SITE PLAN
2260 ANDES WAY
AURORA, CO 80011

TARAHUMARA TRUCKING
 PHASING PLAN
 2260 ANDES WAY
 AURORA, CO 80011

JOB NO	954-1
CAD NO	954-1
DATE	03/30/23
UTILITY PLAN	2260 ANDES WAY AURORA, CO 80011

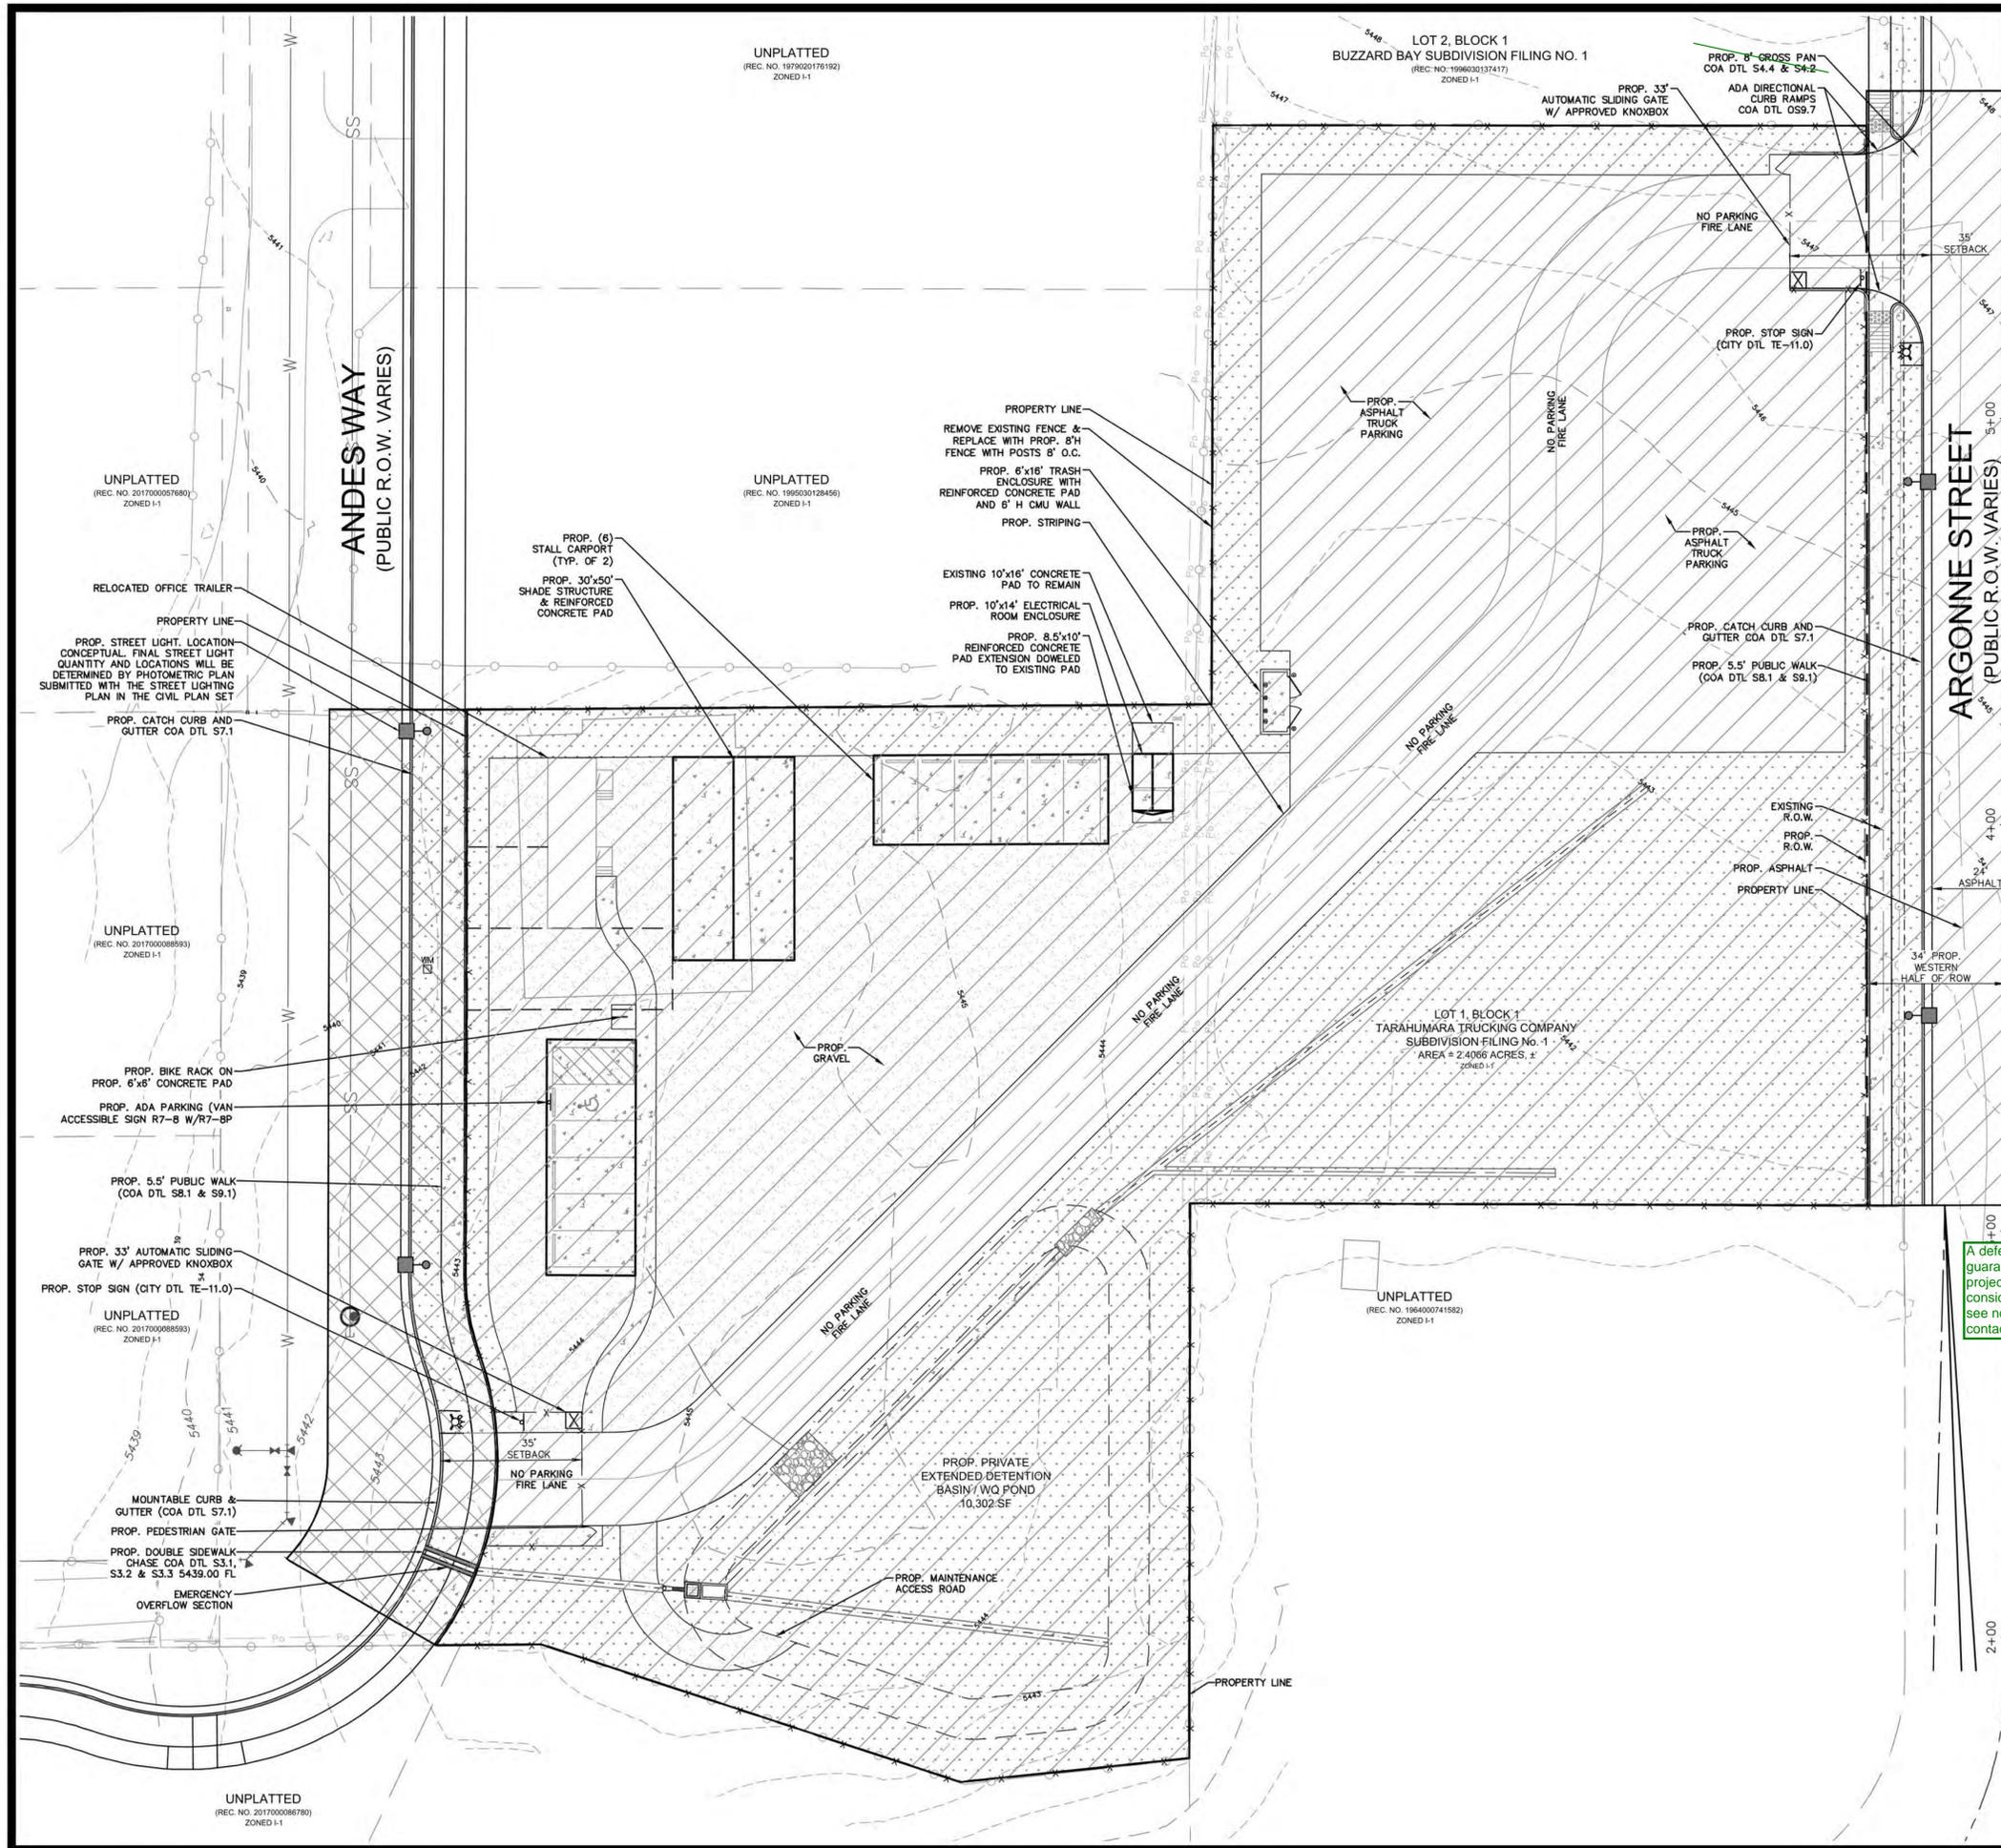
Future Andes Way and Argonne Street improvements are required to be designed and shown. A letter addressed to the Director of Public Works requesting the deferral for improvements including the justification is also required

Please reach out to Kendra Hanagami at khanagami@auroragov.org to start the deferral agreements for Andes Way and Argonne Street

Fix/show property line and centerline linetypes to match legend, typ. ALL

A separate Building Division permit will be required for carport, shade structures, etc.

Per Section 4.07.1.01 - Where fire lanes turn, the inside radius shall be 29' and the outside radius shall be 52'. Where the fire lane width is 26' wide the inside radius shall be 26' with an outside radius of 52'.

all asphalt surfaces shall have a minimum grade of 1%

minimum 2% slope for all non-paved eas, typ.

Dimension spaces. 9x19 is required.

Advisory comment: The fire lane must be constructed to a COA Roadway Standard.

see 2023 Site Plan Checklist Item 2 Graphic (required on site plan sheet): 2. Lot lines and/or the plat boundary line shall be shown with a heavy, solid line. Around the perimeter of the plat boundary or lot lines, show dimensions, bearings, and curve data. This data must match the recorded or proposed subdivision plat information. not shown Lot lines and/or the plat boundary shall be shown with a heavy, solid line etc., see 2023 Site Plan Checklist Item 2

The installation of any gating system will require a City of Aurora licensed contractor to obtain a building permit through the Aurora Building Division prior to the start of any work. This would be considered a structural, life safety and electrical review within the Building Division that is conducted on behalf of the Fire Chief. For assistance please call 303-739-7420 and ask for a Life Safety Plans Examiner.

Please remove reference to cross pan in the site plan. This should be submitted with the civil plan set instead, typ., ALL

During civil plan review curb ramps will need to comply with the current City of Aurora Roadway Design Manual, ALL

should have concrete hatch, please fix, typ. ALL

curbs are required to be sectioned from label curb return diameter at radii, typ. ALL

Is Argonne Street paved?

Please modify linework to not show concrete scoring.

Specify ROW width and roadway classification, typ. ALL

Please add the following note:
"Proposed street light locations are conceptual. Final locations will be determined with photometric analysis submitted with the street lighting plans in the civil plan submittal."

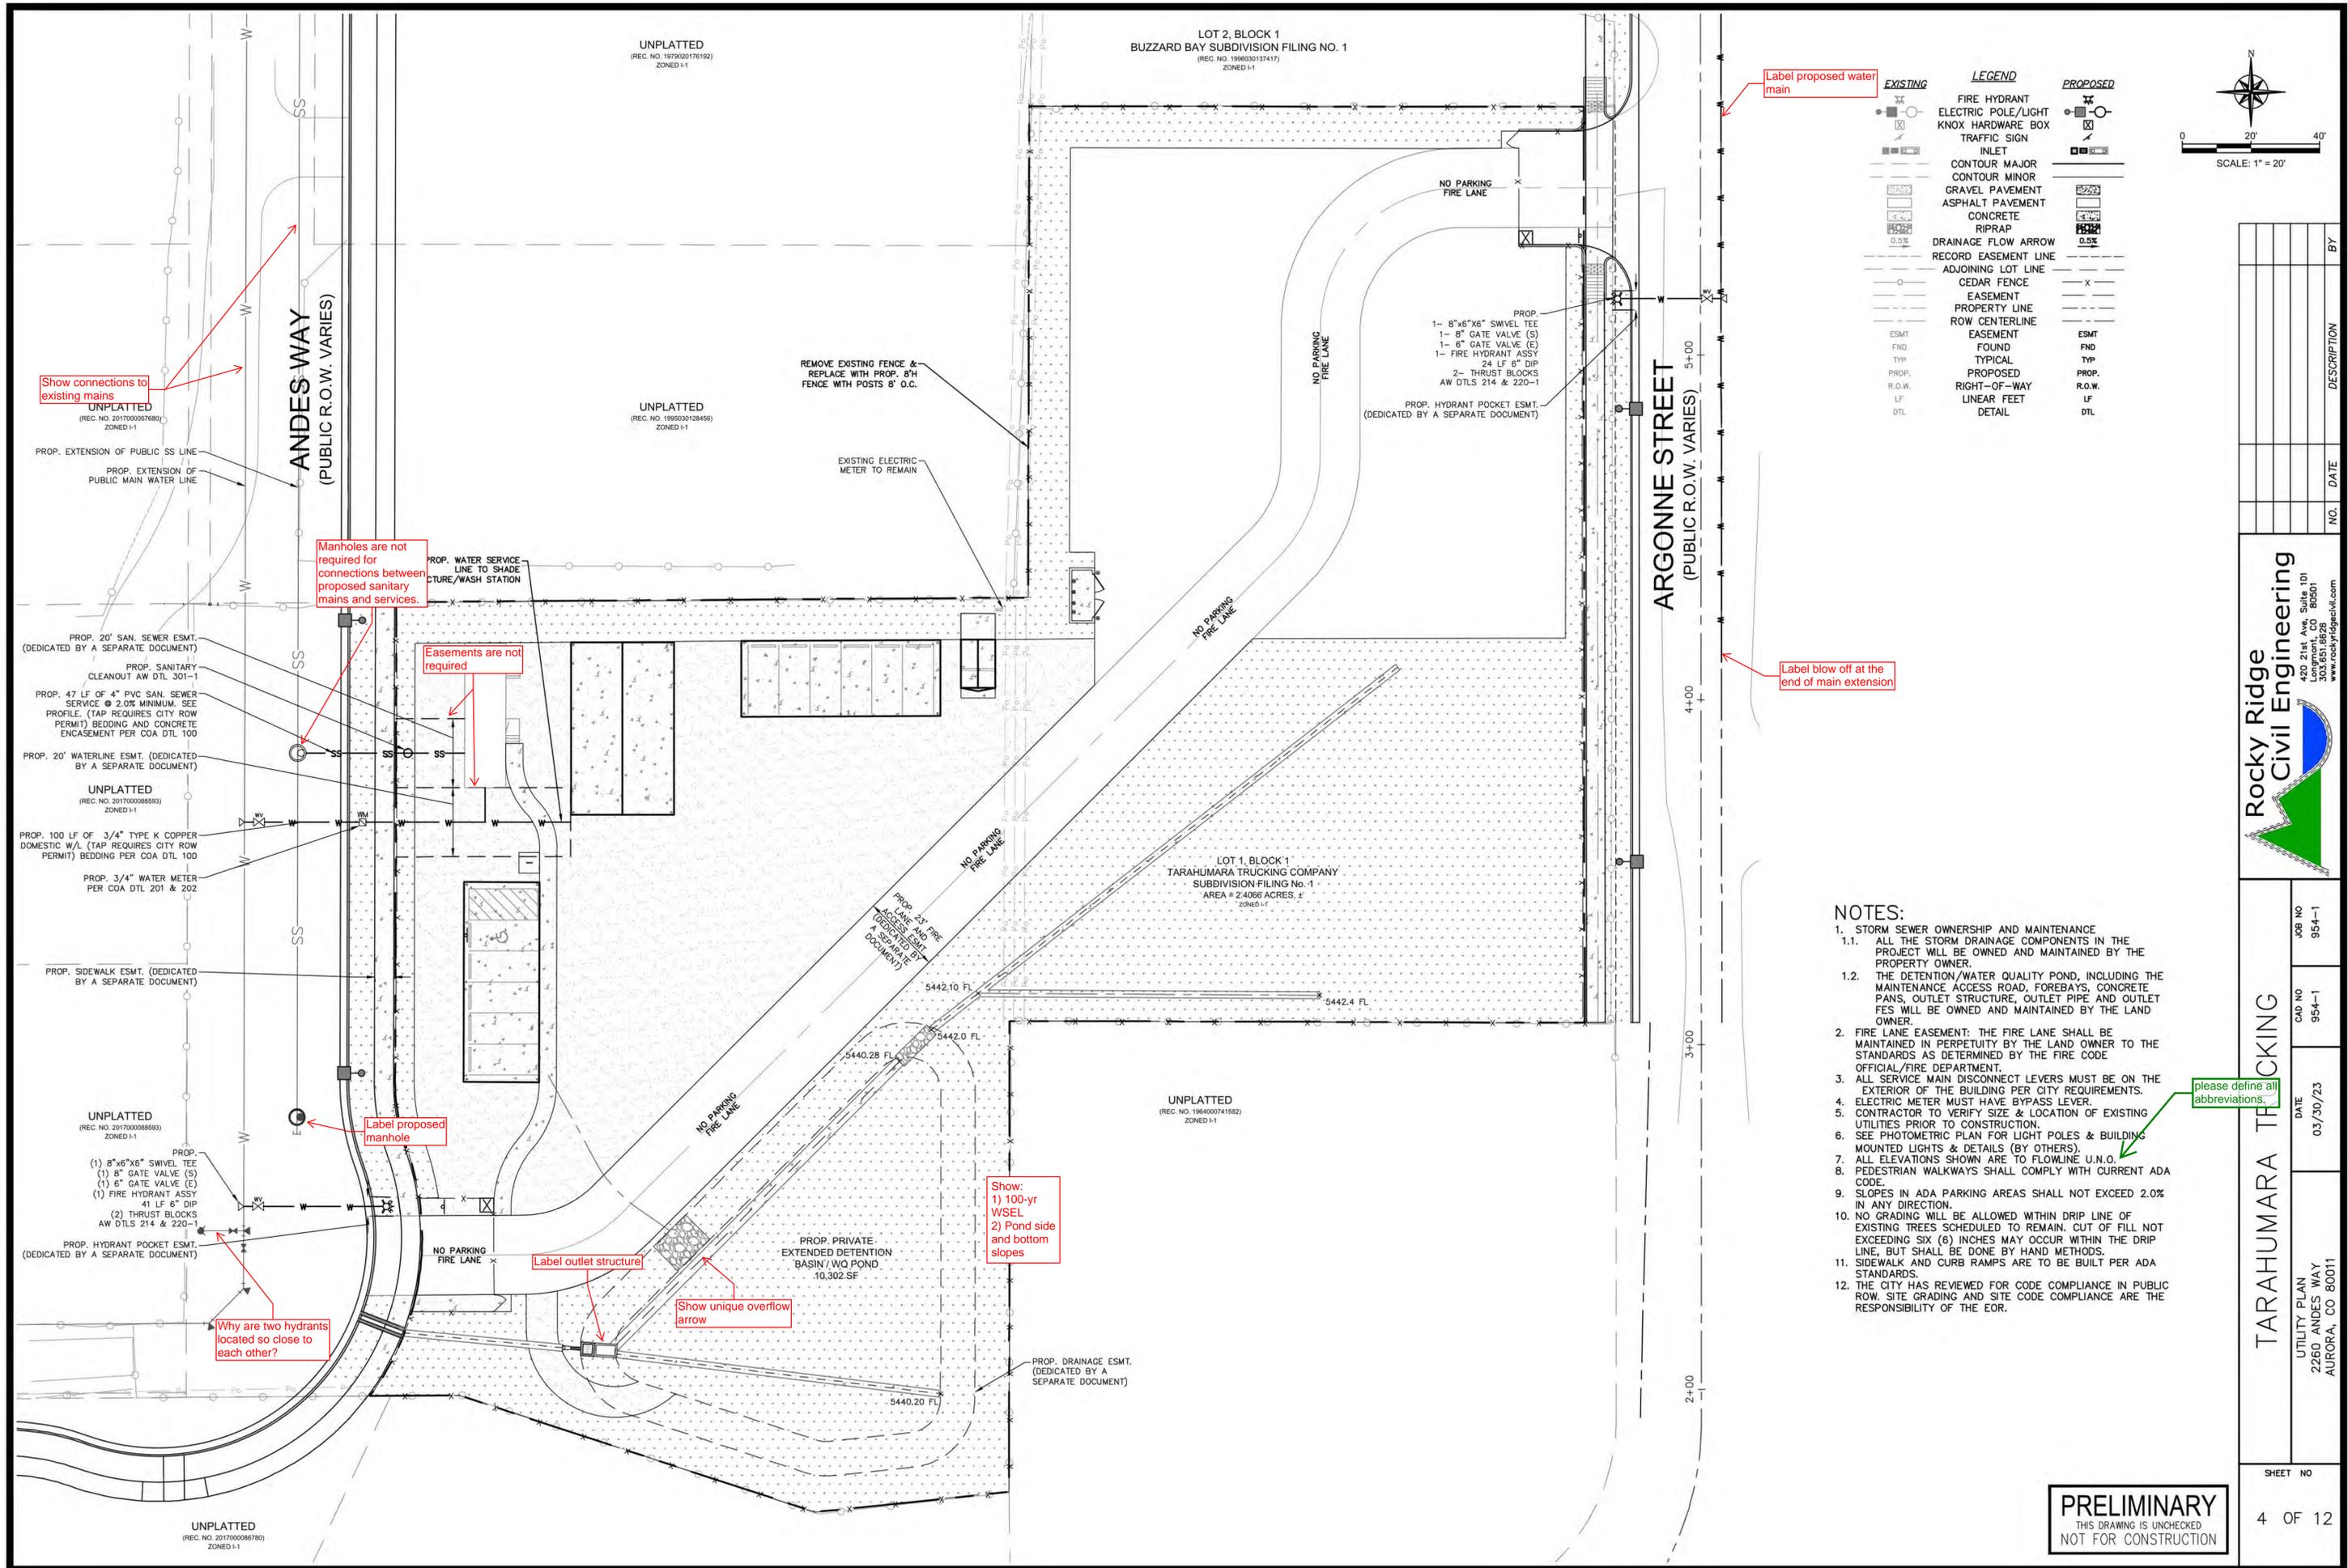
A deferral is not guaranteed for this project, but will be considered. Please see notes below for contact information.

Andes Way was requested in the letter. Please revise if this should be Andes Way

Future Andes Way and Argonne Street improvements are required to be designed and shown. A letter addressed to the Director of Public Works requesting the deferral for improvements including the justification is also required

Please reach out to Kendra Hanagami at khanagami@auroragov.org to start the deferral agreements for Andes Way and Argonne Street(?)

Please resubmit deferral letter, with better justification per the UDO and an exhibit.

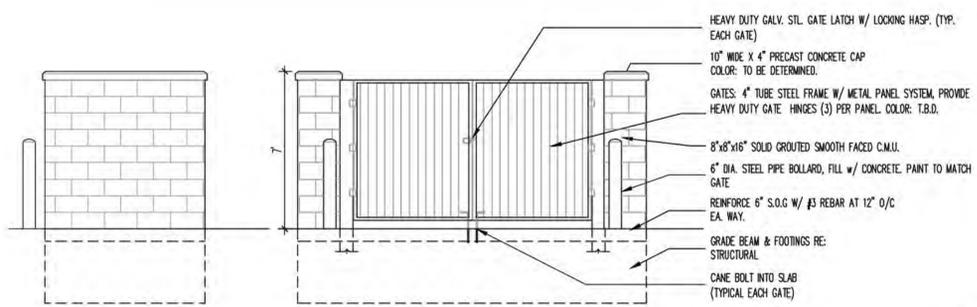
Label proposed water main

Show connections to existing mains

Manholes are not required for connections between proposed sanitary mains and services.

Easements are not required

Label blow off at the end of main extension

Label proposed manhole

Why are two hydrants located so close to each other?

Label outlet structure

Show unique overflow arrow

Show: 1) 100-yr WSEL 2) Pond side and bottom slopes

please define all abbreviations.

ARGONNE STREET & ANDES WAY SECTION
LOCAL TYPE 3 (S1.2)
(TYPICAL)
N.T.S.

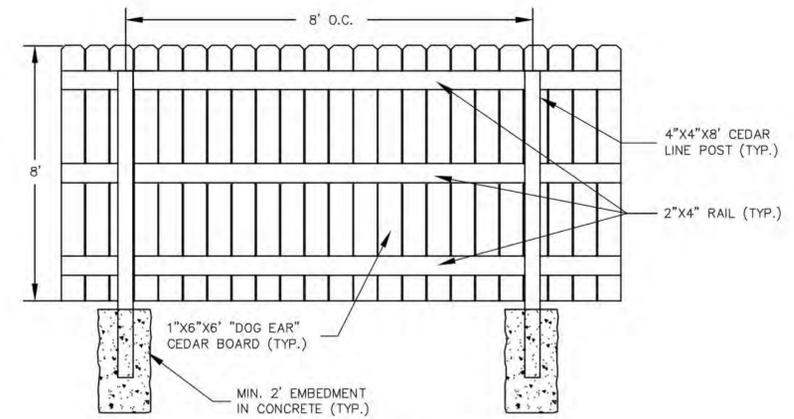
Please provide two different typical sections for Andes Way and Argonne Street (to make it clear which street is requesting a deferral).
A deferral is not guaranteed, please refer to previous notes

AUTOMATIC GATE DETAIL
N.T.S.

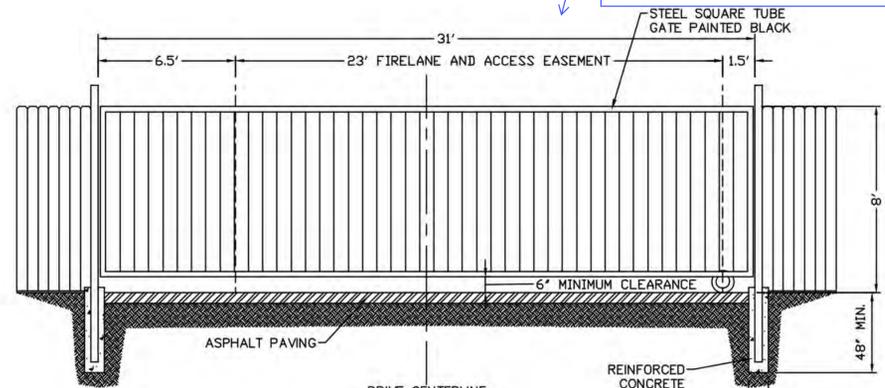
23? Please be consistent with previous sheets

The gate label must include width, operating mechanism, Knox hardware, automatic/manual, etc., details. Example 23' Automatic Sliding Gate with approved Siren Operated System, Knox Key Switch and Manual Release.

PAVED FIRE ACCESS
(TYPICAL PAVEMENT STRUCTURE PER 5.01.2.03.2.)
N.T.S.

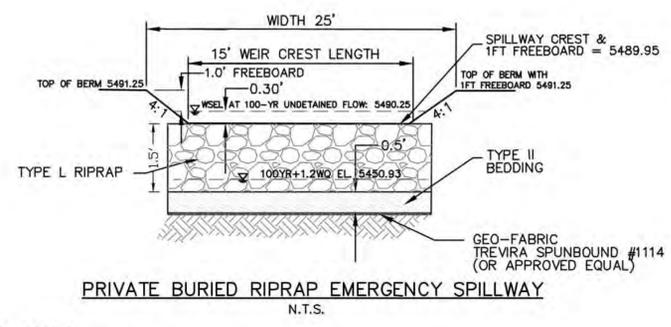
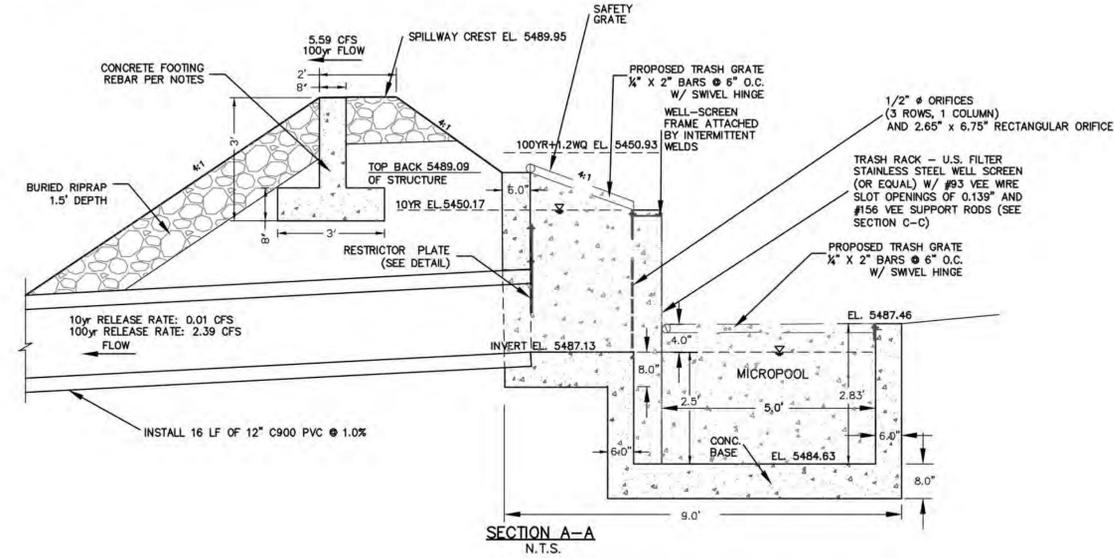
Please remove this level of detail from the site plan - please include in civil submittal.

Please remove this level of detail from the site plan - please include in civil submittal. Per Section 4.07.2 - the pavement design for fire lanes, private streets or drives and parking lots shall be in conformance with Section 5.00 Pavement Design.
